# Stiletto Notes

**Plate 19-E** - Methods for handling thickness variations between side and bottom planking at junctions over chine log. (*From BOATBUILDING WITH PLYWOOD*)

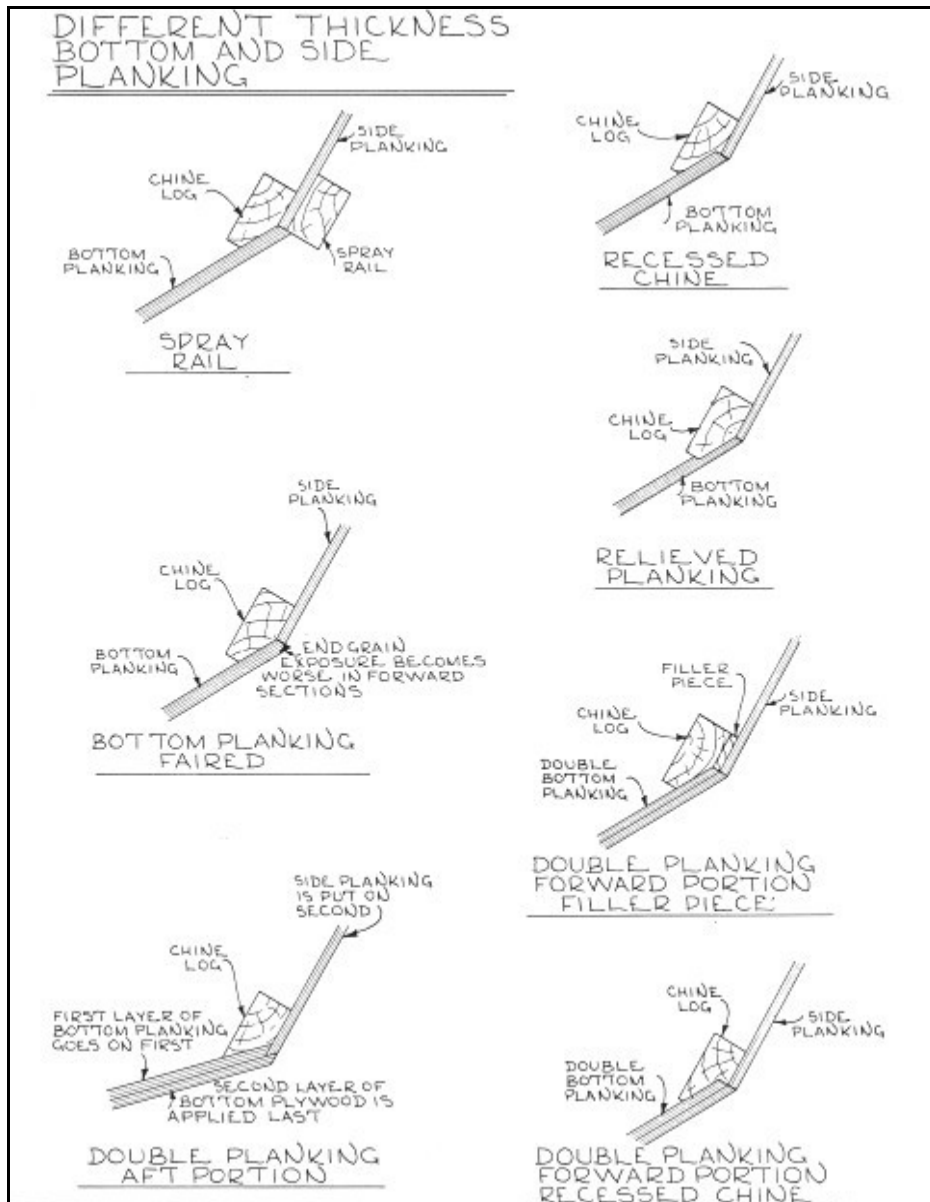
**Question:** I am building a Stiletto and would like to know about fairing, if any, of the spray rail. When the rail is installed, the bottom edge is not on the same plane as the hull planking, should it be? Or should it be left to cut spray?

**Answer:** First, a spray rail might provide some advantages, but it is not normally used on a boat of this type... it doesn't look cool.

If you use one, the hull would be fiberglassed, then the spray rail fastened to the side planking, resting against the edge of the bottom planking, any gaps filled with thickened Poxy-Shield. The purpose of a spray rail, in addition to hiding this joint, is to deflect spray; it is not faired.
